## TEXAS COMMISSION ON ENVIRONMENTAL QUALITY

NAME OF PROJECT: Oak Run Commercial Reserve, Unit 11; Located on the northwest corner of State Highway 46 and Oak Run Parkway; New Braunfels, Texas

TYPE OF PLAN: Request for the Approval of a Water Pollution Abatement Plan; 30 Texas Administrative Code (TAC) Chapter 213

Re: Response to TCEQ Comments dated April 24, 2014  
Edwards Aquifer, Comal County  
NAME OF PROJECT: Oak Run Commercial Reserve, Unit 11; Located on the northwest corner of State Highway 46 and Oak Run Parkway; New Braunfels, Texas.  
TYPE OF PLAN: Request for Approval of a Water Pollution Abatement Plan; 30 Texas Administrative Code (TAC) Chapter 213 Edwards Aquifer;  
Investigation No. 1158180; Regulated Entity No. RN107166928; Additional ID No. 13-14032501

EXISTING IMPERVIOUS COVER EXHIBIT  
OAK RUN COMMERCIAL RESERVE,  
UNIT 11 - INFRASTRUCTURE

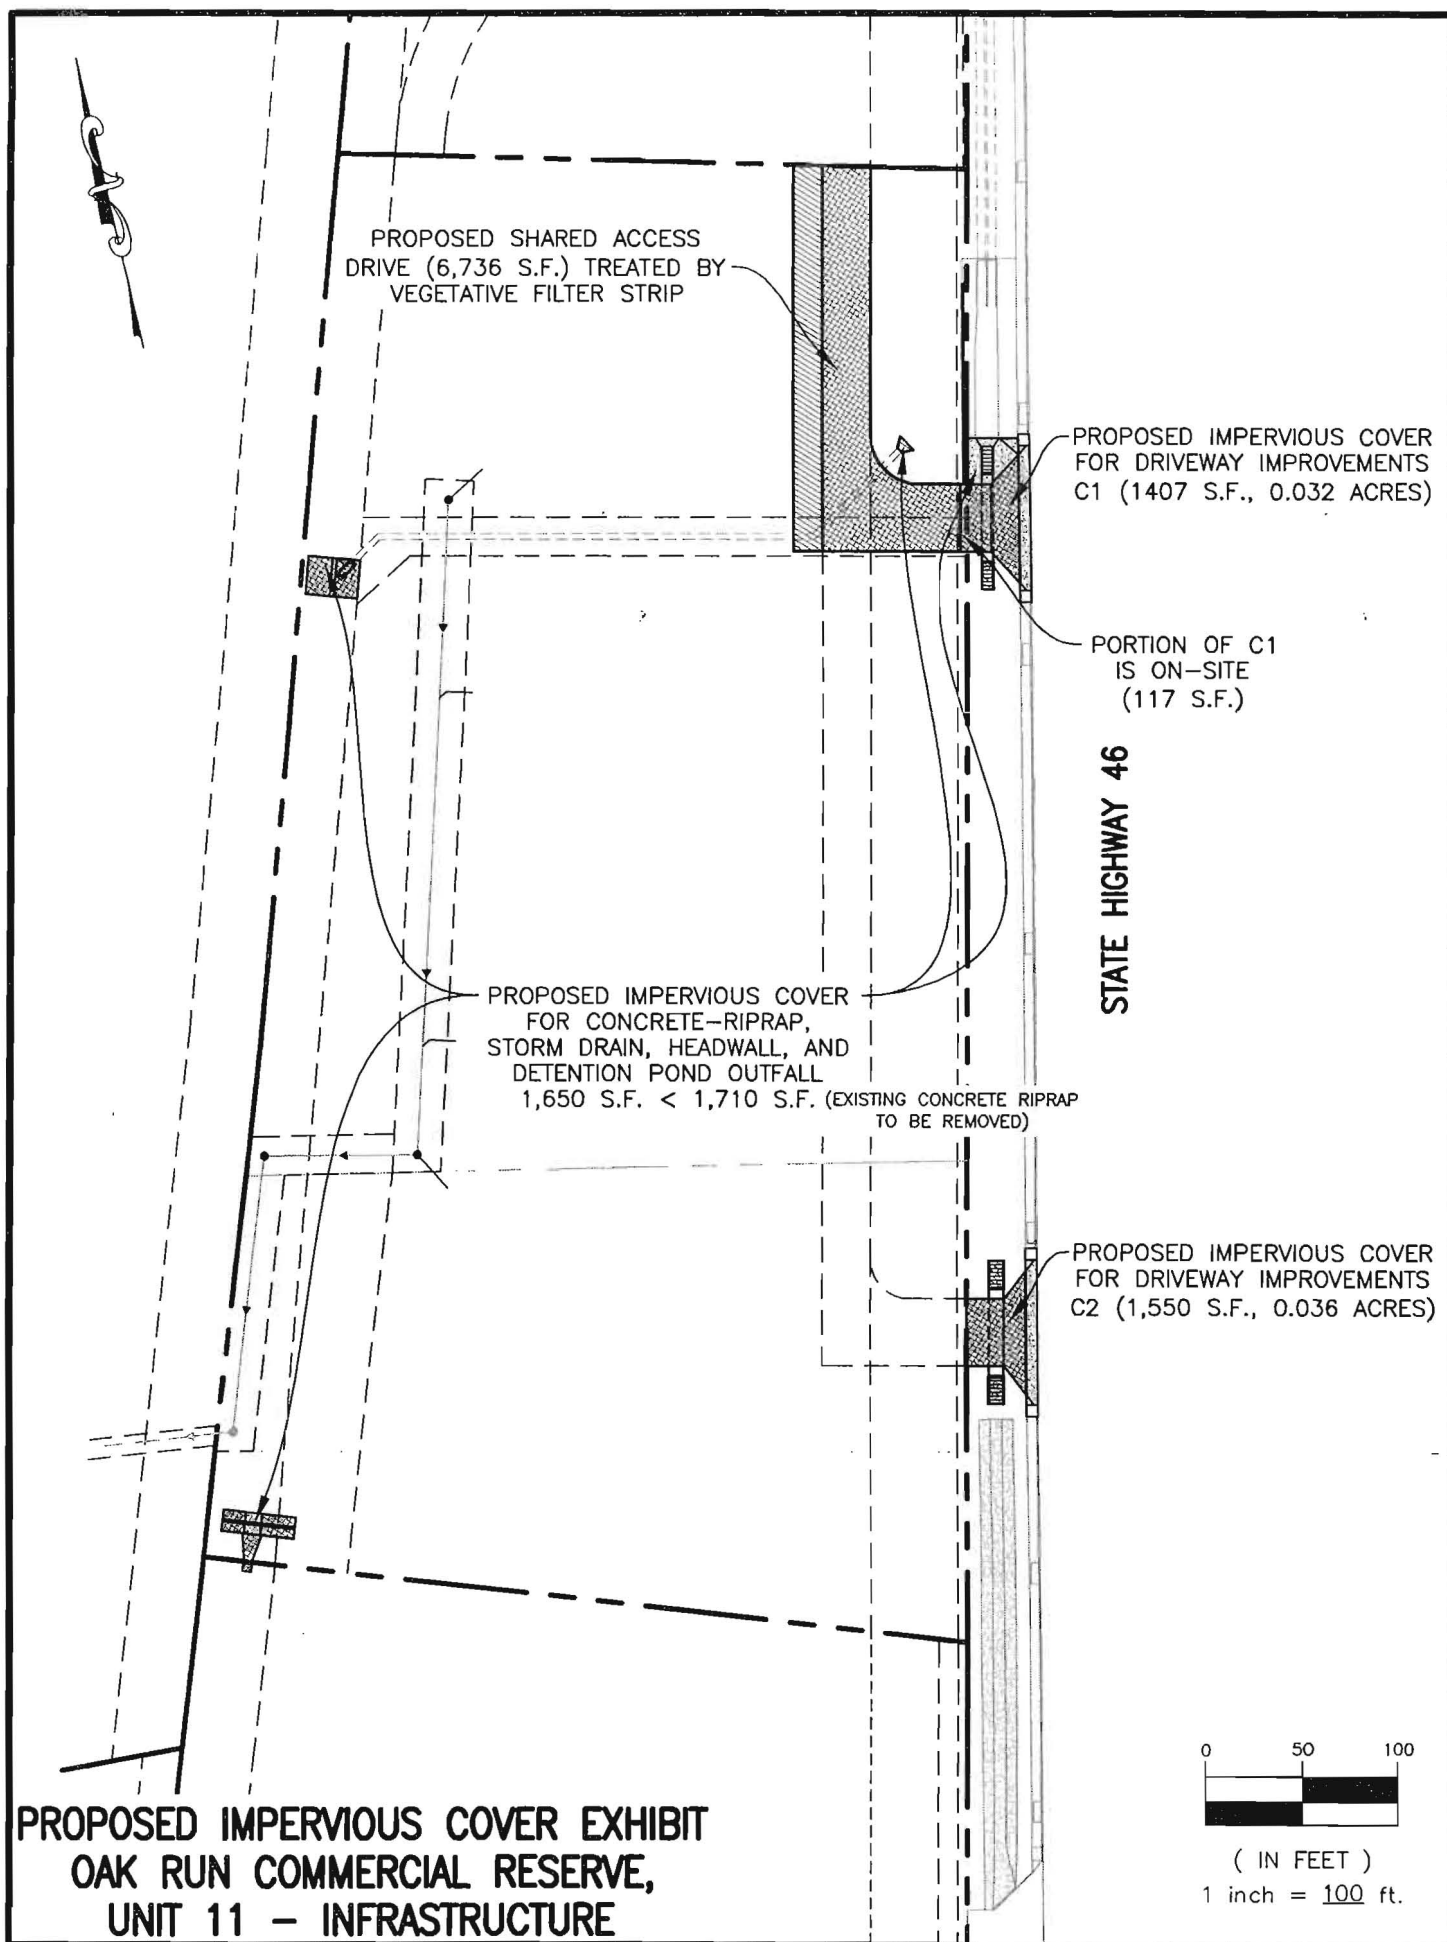
| 6 | Since a portion of existing concrete riprap (1,710 sf or 0.039 ac) impervious cover is in TxDOT's channel on the north side SH 46 at the Proposed Driveway #1 location is being removed, the table has been modified on S1 to demonstrate that the proposed impervious cover of the proposed concrete elements (ie, headwall, pilot channel, detention pond outfall, and riprap) have an impervious cover of 1,650 sf or 0.038 ac which is less than the existing being removed and |

exhibits showing existing and proposed impervious cover are attached.

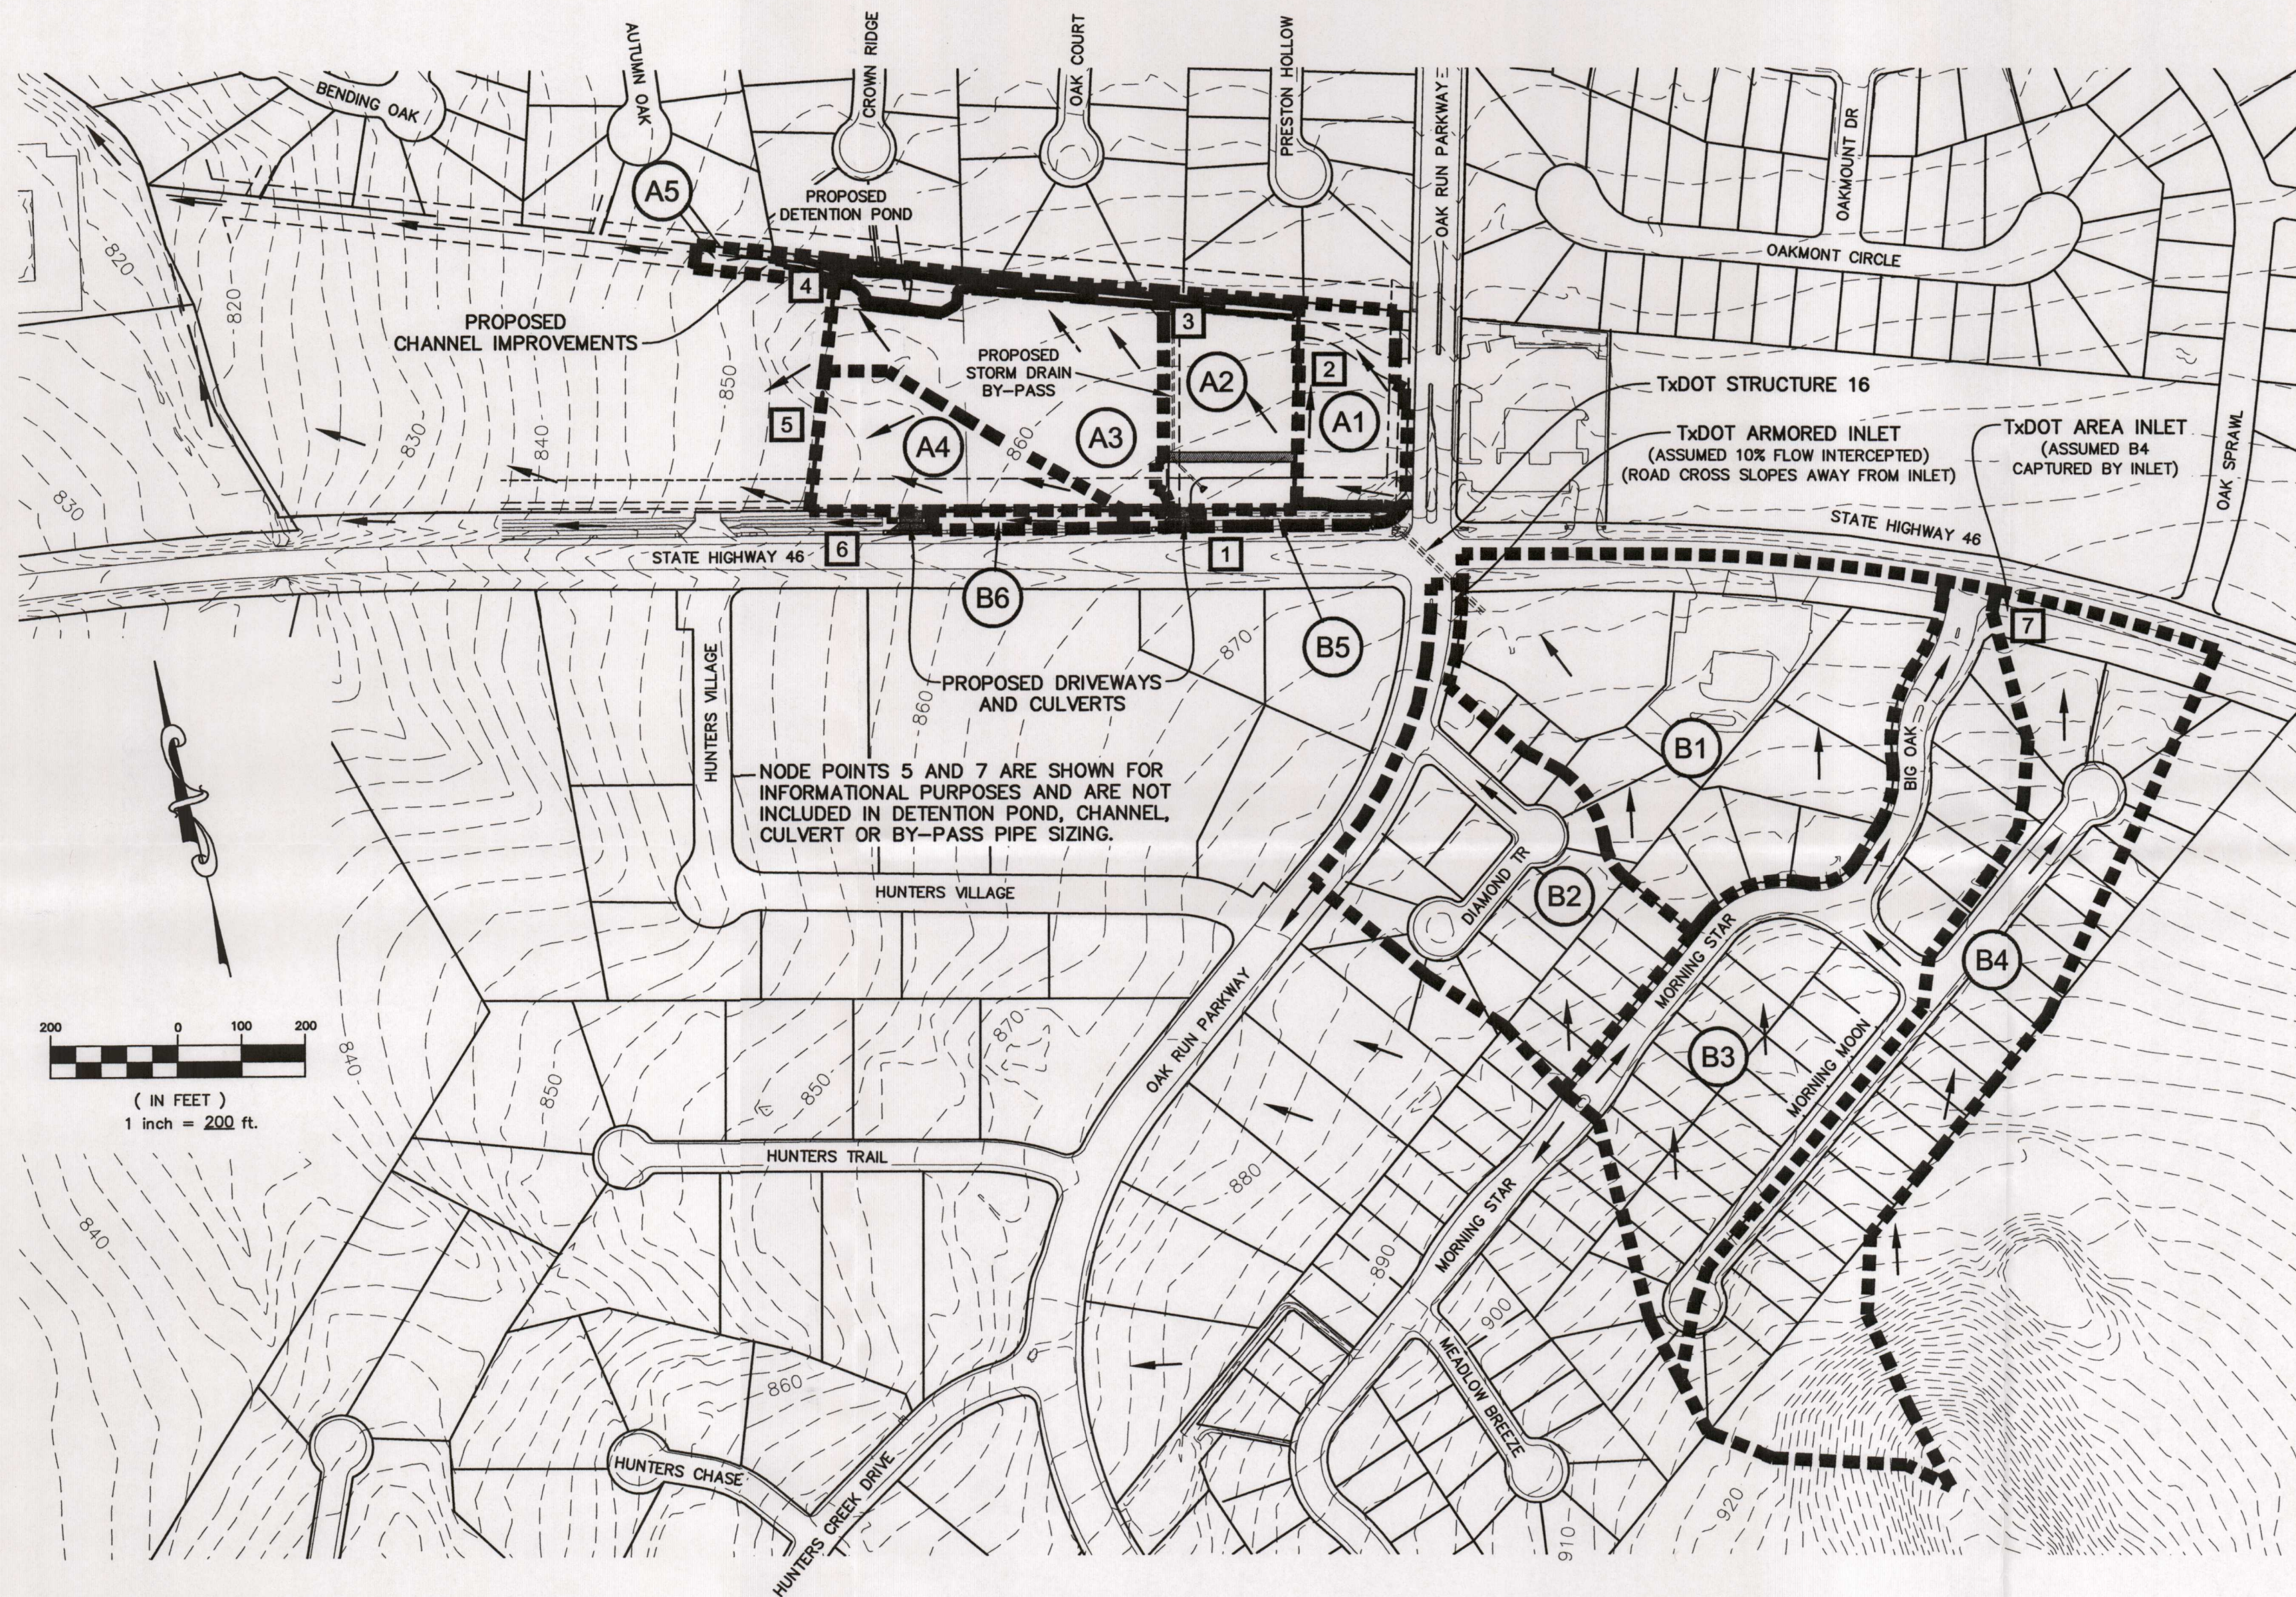
| 4 | Regarding inlet protection during construction of the two proposed driveways, a curb inlet protection detail and notes have been added to S1 and additional inspection form for Inlet Protection is attached.   |

| DATE     | DESCRIPTION                       |
|----------|-----------------------------------|
| 05/02/14 | REVISED PER 4/24/14 TCEQ COMMENTS |
